**Subject: Summary of Projection Repair Letter
Lot No. 14 – (368 Village Bend Drive)
Olde Mill Village Subdivision
Fuquay-Varina, North Carolina
Permit Number: 2008-0066
SUMMIT Project Number: 3241-14R (30951-01)
Order Numbers: N/A**

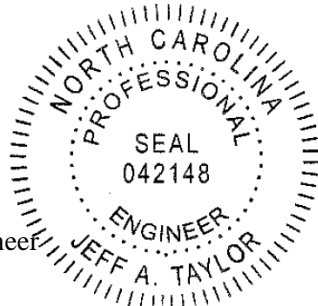
On January 18, 2021, SUMMIT Engineering, Laboratory and Testing, P.C. (SUMMIT) was informed that an area of the footing did not pass projection inspection. SUMMIT was requested to provide repair recommendations for the areas where the required projection is not available. Our repair recommendations are listed below.

In all areas of inadequate footing projections, the new footings shall be excavated and poured to match the existing footing depth. The new footing shall be secured to the existing footing with #4 rebar dowels spaced at a maximum of 12 inches on center with a minimum of 2 dowels per footing projection segment. The dowels shall be drilled and epoxied, mid-depth, with Simpson SET epoxy or equivalent. The dowel holes should be drilled perpendicular into the existing concrete and shall not be angled. The dowel hole for #4 rebar should be drilled with a 5/8" concrete bit. The rebar dowels shall have a minimum 3" cover and minimum embedment of 5" into both the new and existing footing. The epoxy shall be placed in a hole that is drilled and thoroughly cleaned per the manufacturer's specifications.

After the holes were drilled SUMMIT inspected the dowel holes cleanliness and depth. Photographs of the rebar and epoxy application were provided by Mr. Carter. Based on our site observations and the photographs provided, the foundation and projection repairs were in conformance with our recommendations.
